SHEET JC-3 OF JC-22  
ILLINOIS DEPARTMENT OF TRANSPORTATION  
F.A.I. 94/90 (DAN RYAN EXPRESSWAY)  
31ST STREET TO 71ST STREET  
NB EXPRESS LANE RECONSTRUCTION  
JUNCTION CHAMBER, TYPE 2  
REINFORCEMENT DETAILS 1  
SCALE: N.T.S. DRAWN BY: DJM  
DATE: 07/07/05 CHECKED BY: BLU

**TOP SLAB PLAN**

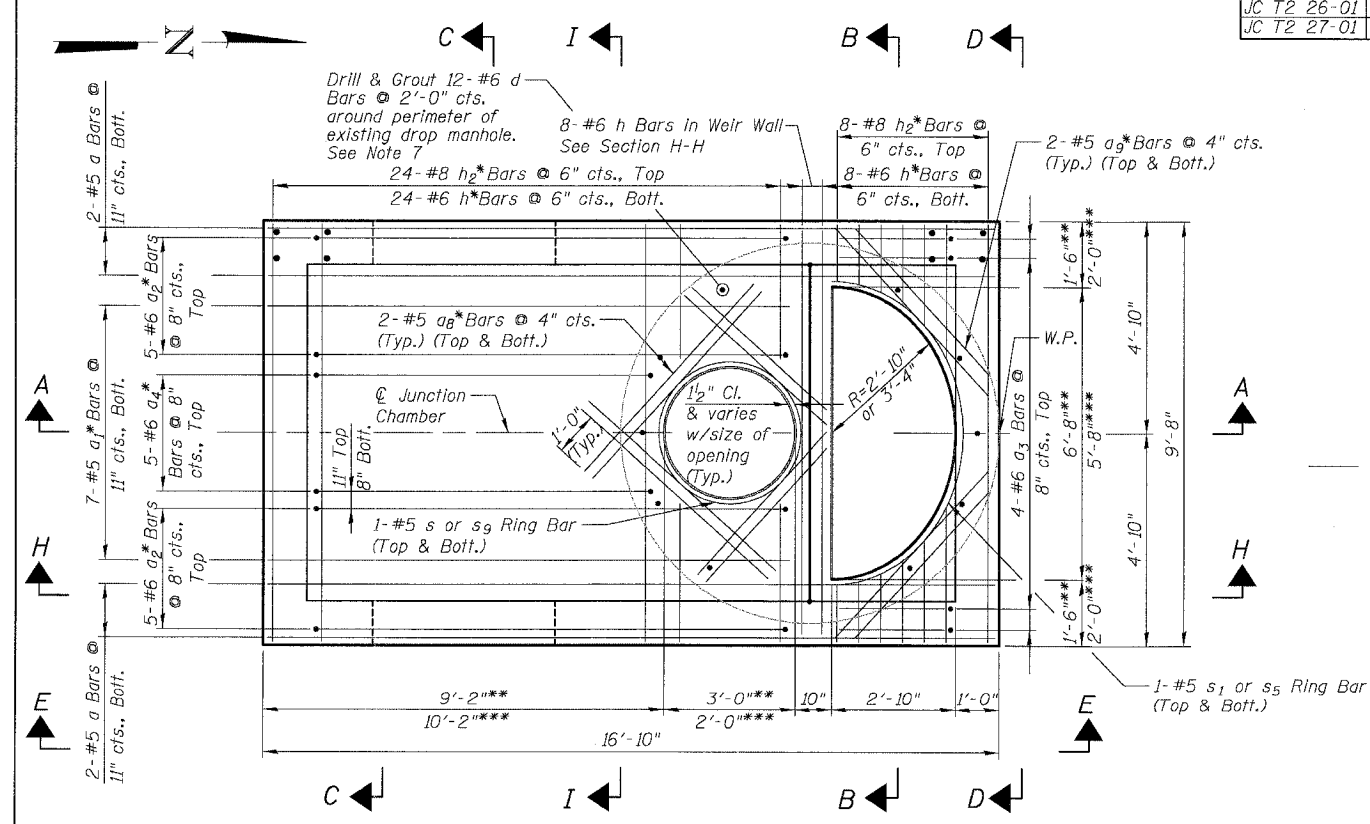
Adjust openings in top slab for final location of frame and grate required due to roadway barrier location. Adjust reinforcement as required for position of openings.
